**ASHLAND PLANNING DEPARTMENT  
PRE-APPLICATION CONFERENCE  
COMMENT SHEET**  
September 13, 2023

**SITE:** 452 Williamson Way  
**APPLICANT:** Rouge Development  
**REQUEST:** 4 Lot Subdivision with  
residential site design review for two zero  
lot line townhomes.

## Ashland Fire & Rescue Pre-Application Report

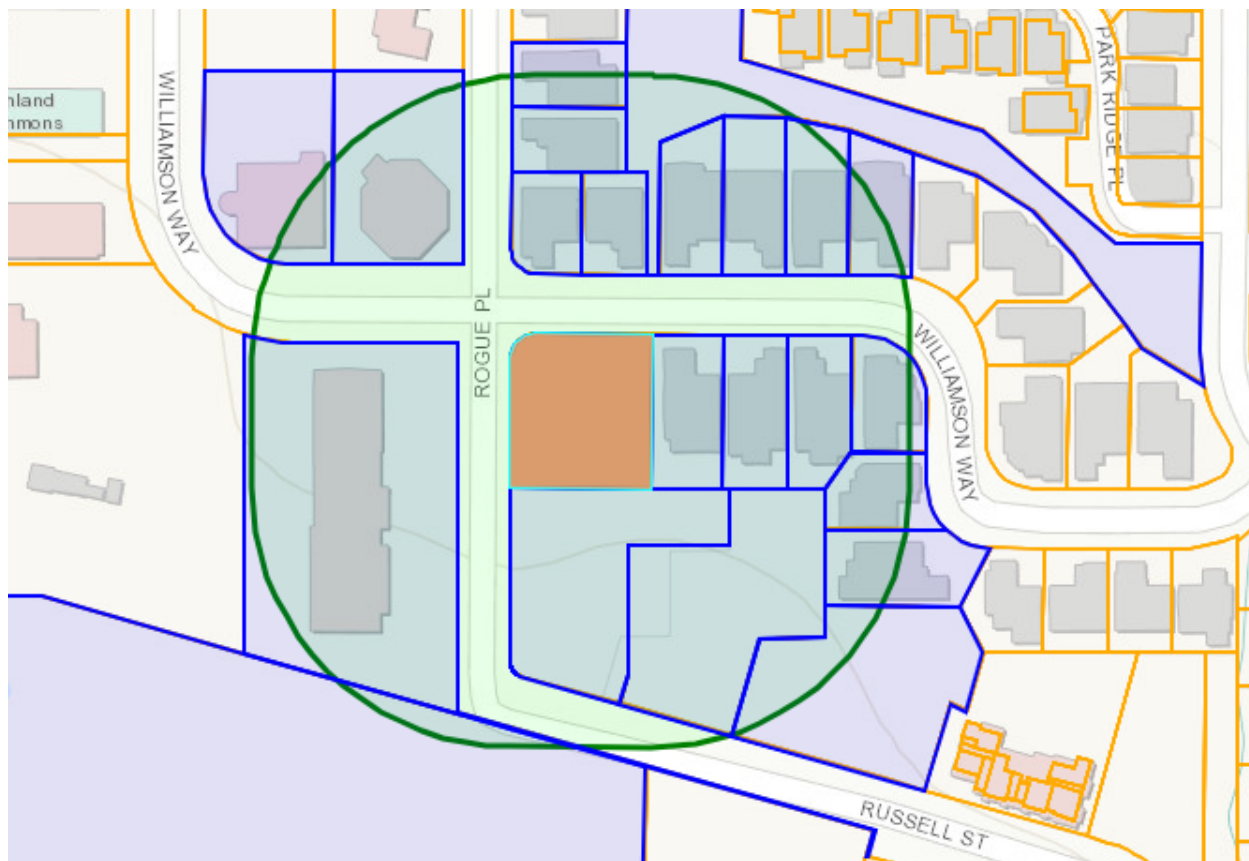
**E1 Zone generally:** The E1 zone has no minimum lot area, width or depth, or maximum lot coverage; or minimum front, side or rear yard. The E1 zone does require at least 15% landscape area.
